AMENDMENT E CHANGES. SHOWN CLOUDED.

VIEWS FROM FISHERMANS BEACH AND THE RESERVED HAVE BEEN UPDATED WITH NEW PROPOSAL.
DRAWING REGISTER UPDATED.

DEVELOPMENT APPLICATION SUBMISSION FOR:

41 & 43 BEACH ROAD,COLLAROY, 2097
LOT 1 DP300846 & LOT 2 SEC 7 DP7391

01 PARTIAL SECTION B-B'

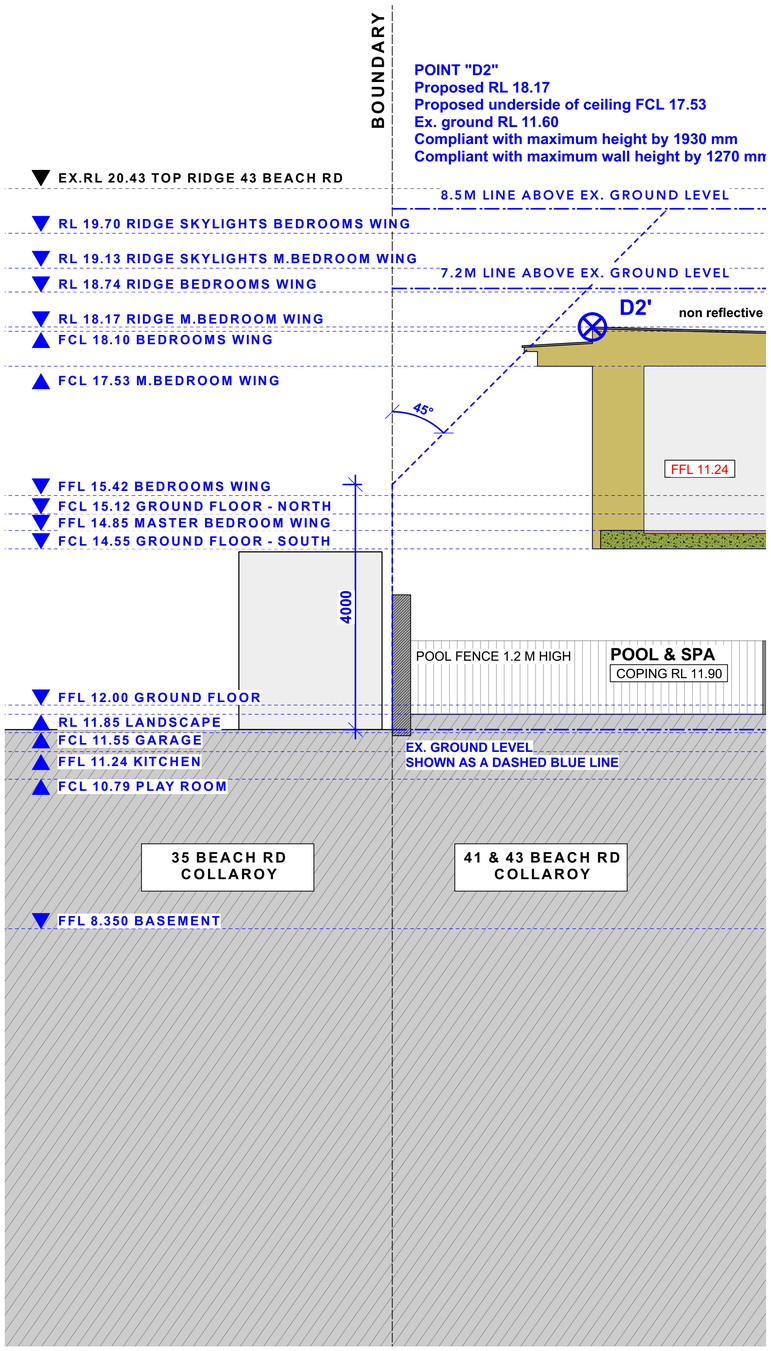
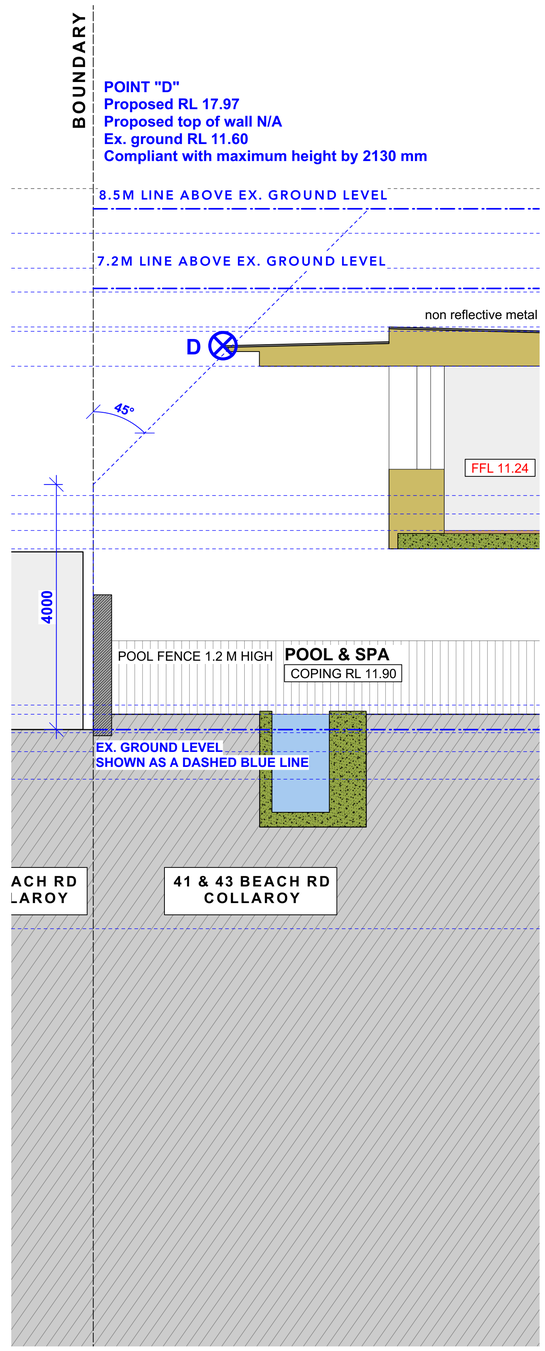
- Southern fence on top of stone retaining wall has been reduced in height from 1.8 m to 1.2 m. To be see-through. Refer to DA 610.
- No changes are proposed to the building. Proposal to remain as per Amendment D previously lodged.

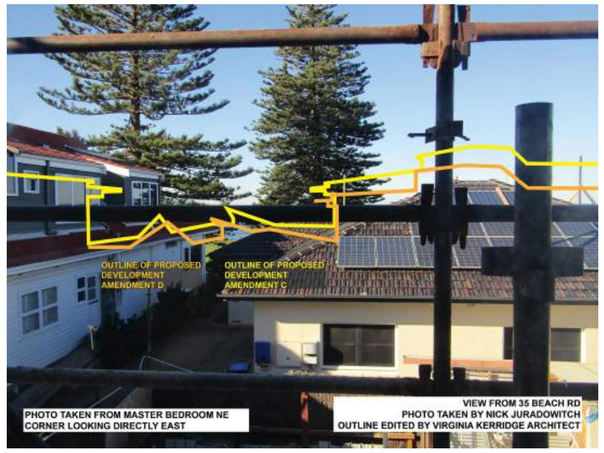
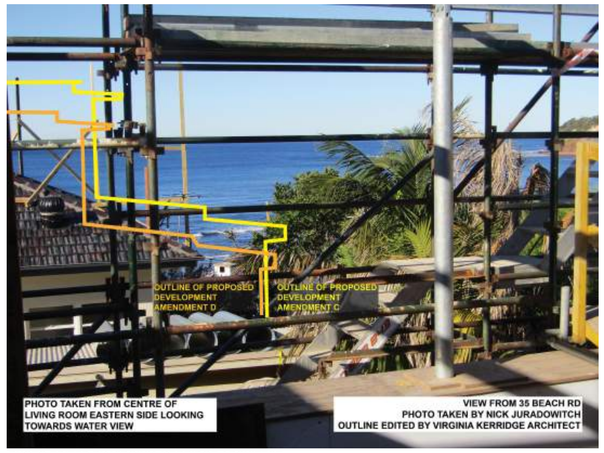
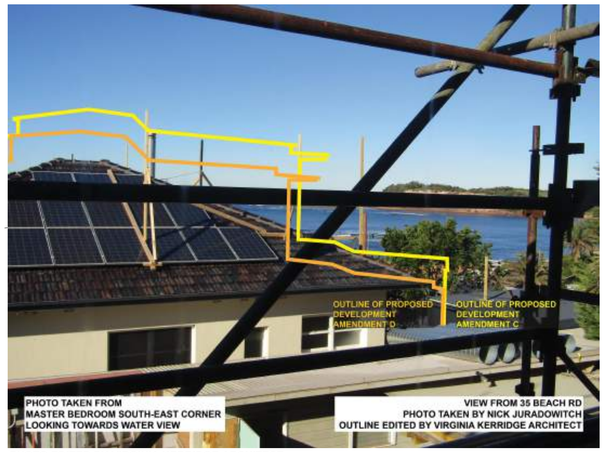
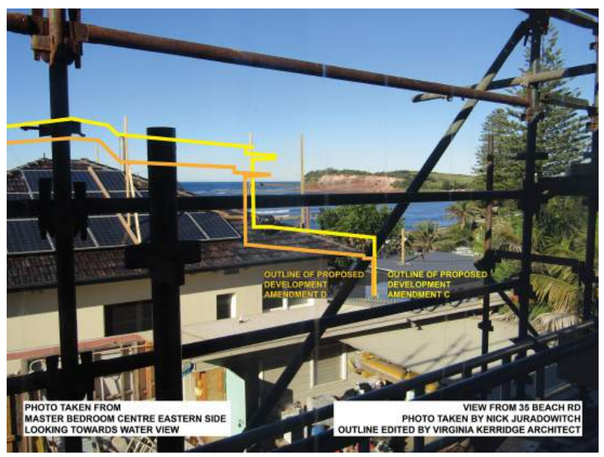
PHOTO EDITED BY VIRGINIA KERRIDGE ARCHITECT.
OUTLINE OF PREVIOUS PROPOSED DEVELOPMENT SHOWN AS A YELLOW LINE - AMENDMENT C
OUTLINE OF CURRENT PROPOSED DEVELOPMENT SHOWN AS AN ORANGE LINE - AMENDMENTS D & E

PHOTO EDITED BY VIRGINIA KERRIDGE ARCHITECT.
OUTLINE OF PREVIOUS PROPOSED DEVELOPMENT SHOWN AS A YELLOW LINE - AMENDMENT C
OUTLINE OF CURRENT PROPOSED DEVELOPMENT SHOWN AS AN ORANGE LINE - AMENDMENTS D & E

PHOTO EDITED BY VIRGINIA KERRIDGE ARCHITECT.
OUTLINE OF PREVIOUS PROPOSED DEVELOPMENT SHOWN AS A YELLOW LINE - AMENDMENT C
OUTLINE OF CURRENT PROPOSED DEVELOPMENT SHOWN AS AN ORANGE LINE - AMENDMENTS D & E

PHOTO EDITED BY VIRGINIA KERRIDGE ARCHITECT.
OUTLINE OF PREVIOUS PROPOSED DEVELOPMENT SHOWN AS A YELLOW LINE - AMENDMENT C
OUTLINE OF CURRENT PROPOSED DEVELOPMENT SHOWN AS AN ORANGE LINE - AMENDMENTS D & E
